ADDENDUM NO. 1

**ELEVATOR ADDITION FOR GW CARVER ES, HENRY COUNTY PUBLIC SCHOOLS
RRMM ARCHITECTS
ROANOKE, VIRGINIA
COMM. NO. 21195-17**

8-11-25

SECTION - 1/S-100 - TYP. ROOF
OPENING FRAME
SCALE: N.T.S.

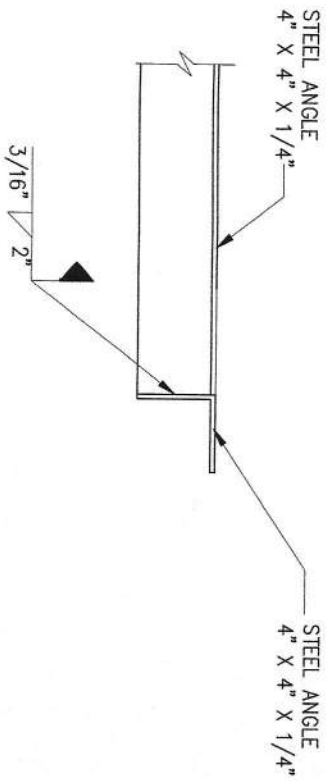
A104 Roof Curb Detail indicates to see structural drawings for steel required for support of roof top unit. There are no details in structural specifying any support for mechanical equipment. Is there any required?

A104-SEE PROVIDED SKETCH FOR ROOF FRAMING DETAIL AT NEW RTU.

DETAIL 2

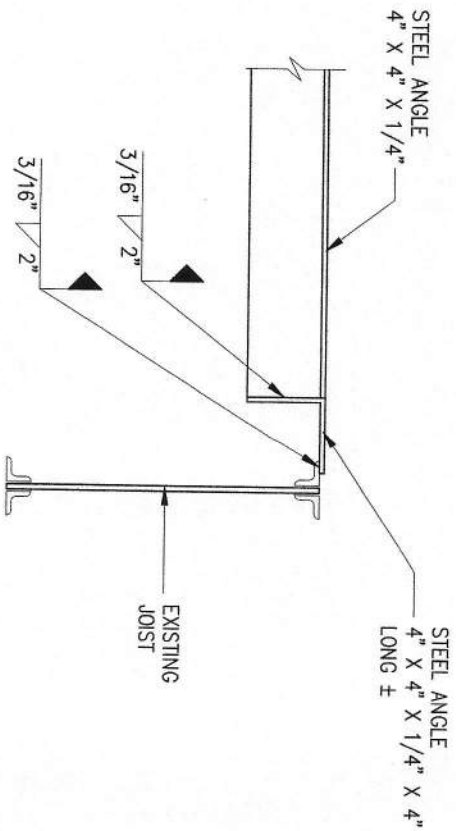
There is an existing downspout catching roof water off the roof at the adjacent building entrance. This downspout is not noted to be removed, replaced, or affected in the drawings but due to the requirement of what would be over excavation to install the elevator pit, this downspout and any of its underground piping will fall directly in the excavation area of the concrete pit. Is the type of piping known? Please confirm and confirm is it required to replace the piping or can downspout just splash on grade?

Please see sketch below for sketch related to existing downspout and UG drainage.

03
A-300 ENLARGED PLAN
SCALE: 1 1/2\" = 1'-0\"

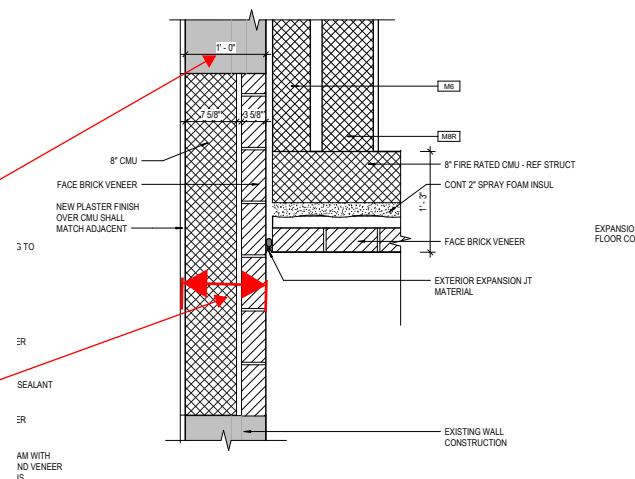
SO. Im looking for either a thickness of existing wall that is on the school now, or a breakdown of the composition of that wall so we know what thickness of CMU to use to fill in what was the window up behind where the new 8" CMU for the elevator shaft is going.

The thickness of the existing wall

The breakdown of the existing wall
